Roads Department – Planning Report

Register Reference: SD22B/0468ai **Date:** 15-Nov-2022
Development: Retention for first floor extension to side of property over existing permitted single storey extension; 2 dormer windows to rear and the re-modelling of fenestration to front elevation at ground floor.
Location: 84, Kiltipper Drive, Aylesbury, Tallaght, Dublin 24
Applicant: Stuart Dicker
App. Type: Retention
Planning Officer: NEAL MURPHY
Date Recd: 26-Oct-2022
Decision Due Date: 20-Dec-2022

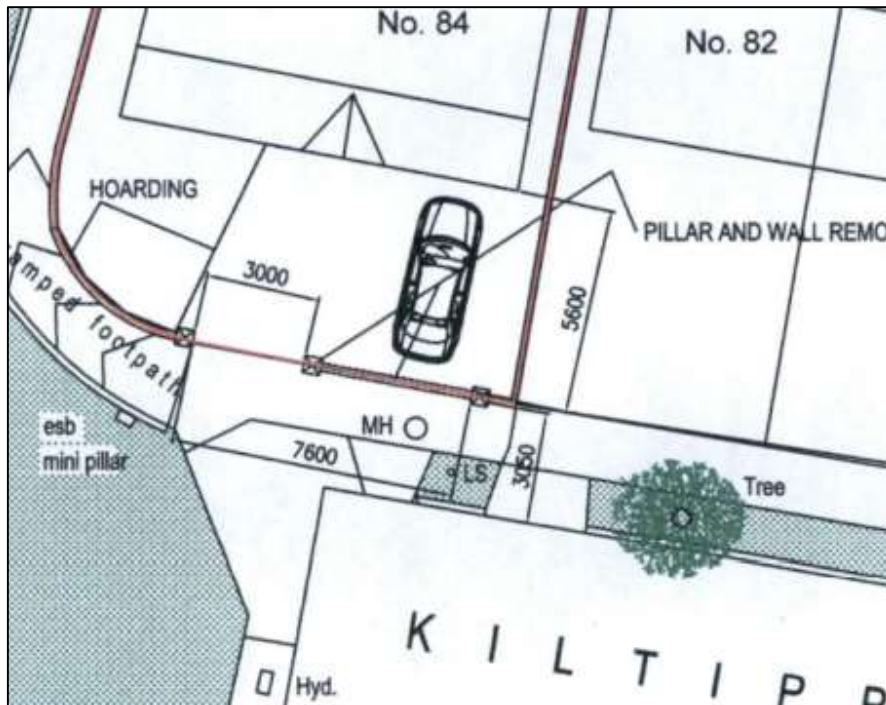
1. The applicant should submit revised drawings including accurate site plans that include the width of the vehicular entrance, the total area of the private open space to the rear and the dimensions of the garden room. The applicant should also confirm the use of the garden room and if there is water and foul connections. Furthermore, the applicant should confirm that the widened vehicular entrance and garden room have the required planning permission.

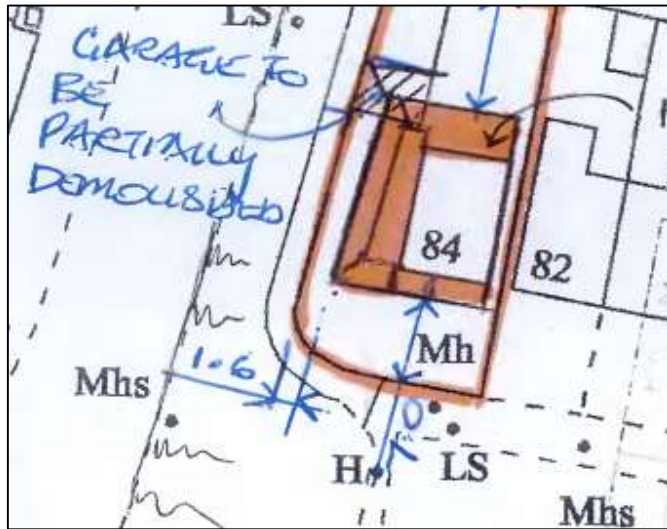
The vehicular access points shall be limited to a width of 3.5 meters. The boundary walls and gates at vehicle access points should be limited to a maximum height of 0.9m, and any boundary pillars shall be limited to a maximum height of 1.2m, in order to improve forward visibility for vehicles, particularly along the curve of the walkway. There should be a minimum of 6.0m from the front of the property to the boundary wall to allow a parked car not to impede on the public footpath when in the driveway. The previous granted planning permission SD16B/0335 detailed the driveway at 7.0m it is now 5.6m.

1. The vehicular access points shall be limited to a width of 3.5 meters.
2. The boundary walls and gates at vehicle access points shall be limited to a maximum height of 0.9m, and any boundary pillars shall be limited to a maximum height of 1.2m, in order to improve forward visibility for vehicles.
3. Any gates shall open inwards and not out over the public domain.
4. All vehicles parked in the driveways must exit the site in a forward direction. No vehicles to reverse onto the public roadway at any time.
5. 6.0m driveway to prevent parked vehicles impeding the public footpath.
